TO: Mercedes-Benz Dealer Principals, General Managers, Sales Managers, Service Managers, Parts Managers	FROM: Gregory Gunther, Department Manager, Vehicle Compliance and Analysis, Engineering Services
RE: <b>Emission Service Campaign 2021070003 Launch Notification</b> <b>Replace Vehicle Emission Control Information (VECI) Label MY20-21 (CLA-Class, GLE/GLS-Class)</b>	DATE: February 11, 2022

Campaign No. 2021070003, February 2022

SUBJECT: **Model CLA-Class, GLE/GLS-Class vehicles (118,167 platform)  
Model year 2020-2021**

## **Replace Vehicle Emission Control Information Label**

Figure 1

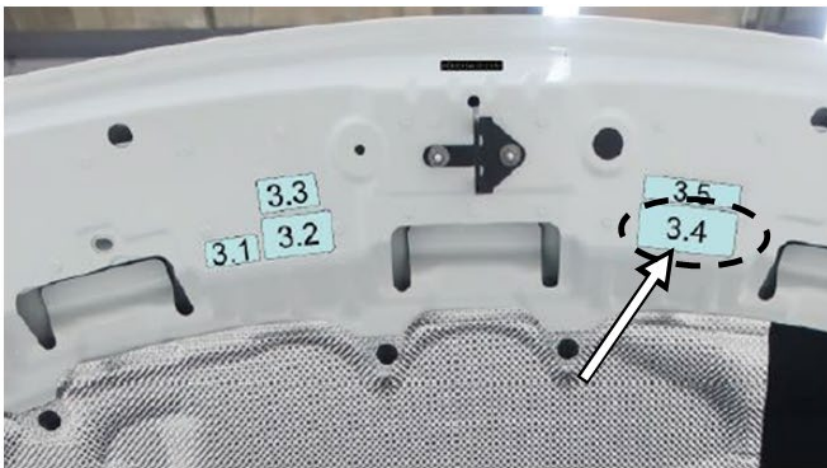
1. Open engine hood
2. Replace information label at bonding position **3.4 (Figure 1)** at inside of hood.

**i** BIN / ULEV 125 must be present on the information label.

**i** Attention: Take into account order information for model 167 with or without code 085!
